LMX9830 Bluetooth Serial Port Module Firmware Release Notes

Texas Instruments
Firmware Release Notes
January 2007
Revised February 2013
Revision 1.4

Figure 1-1. “SimplyBlue Ready” in Simply Blue Commander

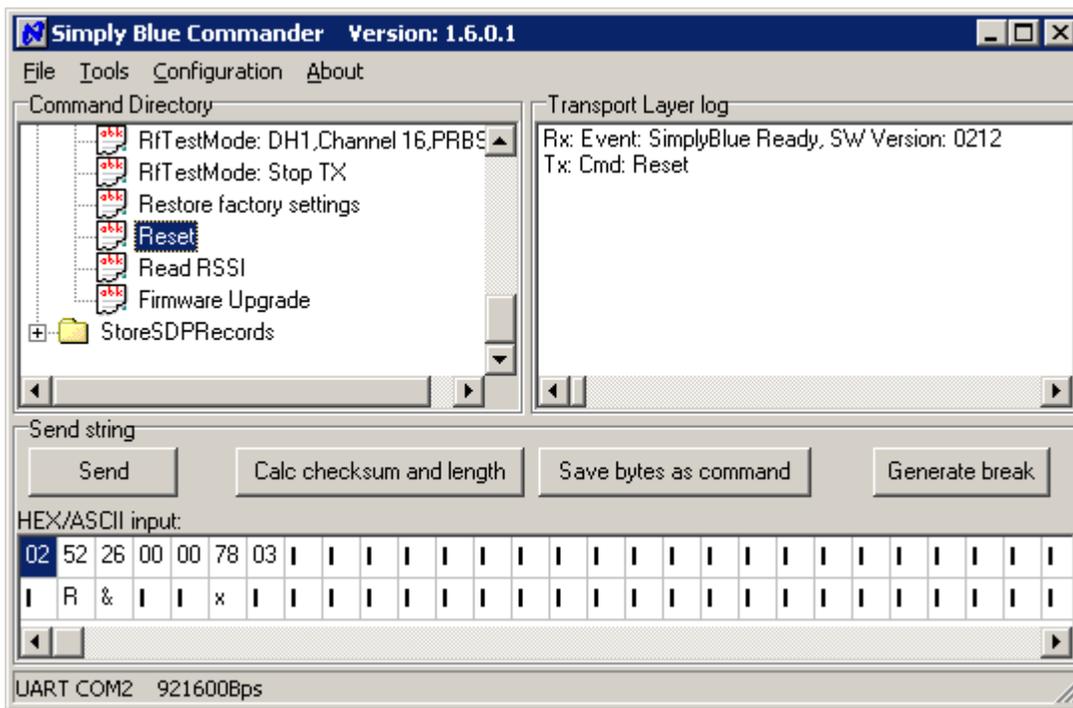
Each LMX9830 comes up with a certain “Ready” Event, which indicates the completed boot process of the device. This event also includes the firmware version of the device. The “Ready” appears after boot or after a software reset.

For example, the LMX9830 will come up with the hexadecimal code

Rx(RAW): 02,69,25,05,00,93,04,**30,32,31,32**,03

on which the bold bytes indicate the firmware version (in this case 0212).

In order to avoid any future upgrade problems, please make sure your software does not use this parameter as part of the decision to continue. The parameter should just be used for informational purposes.

Figure 1-2. Write ROM patch flow

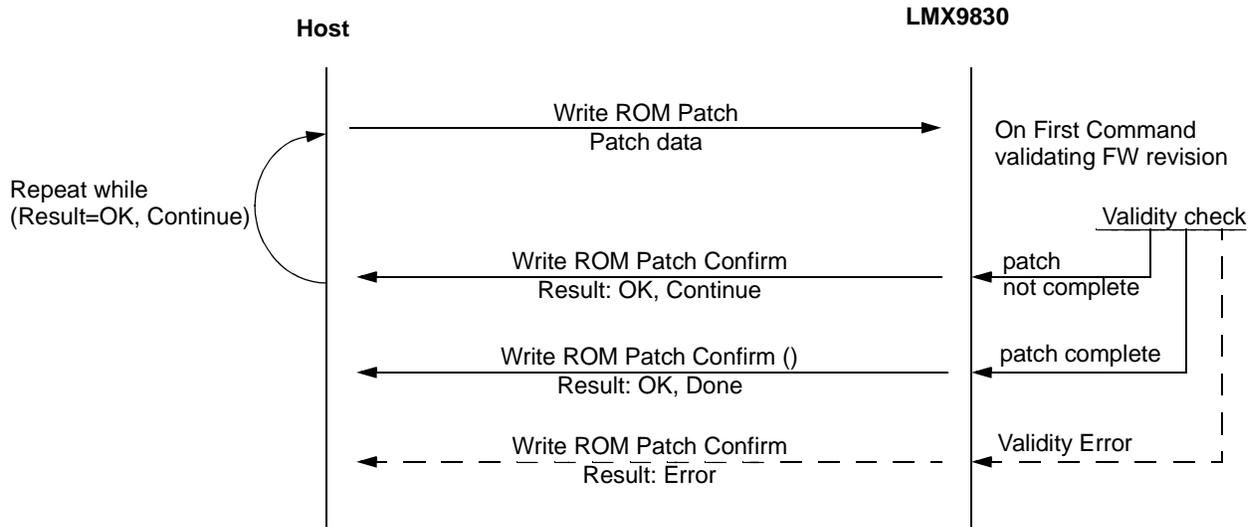
In case no EEPROM is connected, patches need to be supplied via the command interface using the “Write ROM patch” command. Since patches usually require more than one command, the patching requires a specific command flow to be

followed. See Figure 1-2 for the general patch flow. The complete process is also described in the “LMX9830 Software Users Guide”.

So in case the host tries to apply a patch released for firmware 2.10, to a 2.12 device, the confirm will respond with error message 0x84.

Therefore the software needs to be prepared to handle this error code correctly by either continuing with the normal boot process without the patch, or to try to apply a patch for another firmware version.

To be prepared for future upgrades, the host application should not stop the execution due to this error code.
